Report: TAB Report
Function: Test, Adjust, & Balance
Date: 03/02/2026
Completed By: National TAB

**02-23-26 WHATABURGER #1644 GARNER,
NC**

Project: 02-23-26 WHATABURGER #1644 GARNER, NC

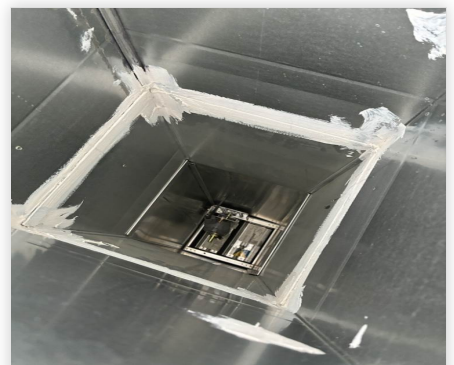
Issue Name : EF-1 Damper Not Opening
Description : The damper in the drop is not opening resulting in low flow for the two bathroom exhaust diffusers. The damper is too far down the drop to be manually opened. The damper actuator wire is not wired to anything. The wire needs to be used in order for the damper to open.
Created By : National TAB **Assigned To :** National TAB - Brianna Biggs
Status : Open
Priority : High **Asset Tag :** EF1
Originated Date : 02/26/2026 - Alex Bauer - National TAB

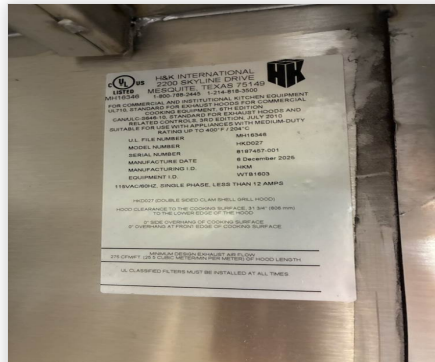
Issue Name : HD-1 Not Wired/Connected
Description : The on/off switch for HD-1 is not wired. The technician from Chisholm Service says the hoods are also not connected to the RTUs. The switch needs to be wired and the hood systems connected to the RTUs.

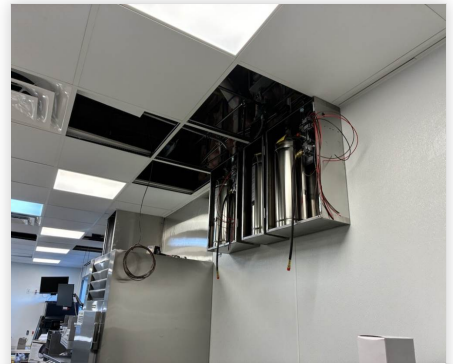
Issue Name : HD-2 Not Wired/Connected
Description : The on/off switch for HD-2 is not wired. The technician from Chisholm Service says the hoods are also not connected to the RTUs. The switch needs to be wired and the hood systems connected to the RTUs.
Created By : National TAB **Assigned To :** National TAB - Brianna Biggs
Status : Closed
Priority : Urgent **Asset Tag :** HD2
Originated Date : 02/23/2026 - Alex Bauer - National TAB

Screenshot of the GRD marked up with supply and return traverse locations for RTU-1 (Add picture here)

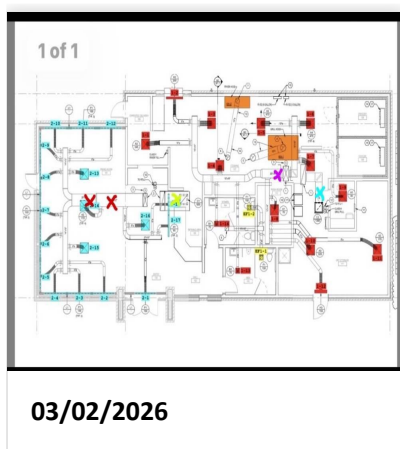
The returns were not traversed as they were not reachable.

Screenshot of the GRD marked up with supply and return traverse locations for RTU-2 (Add picture here)

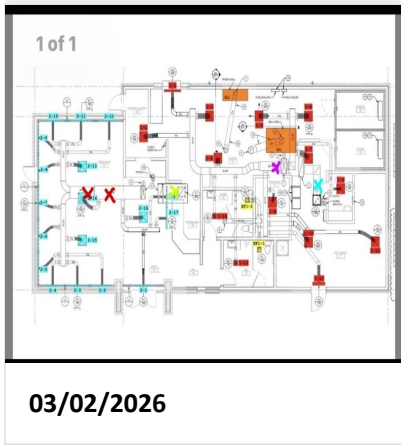
The returns were not traversed as they were not reachable.
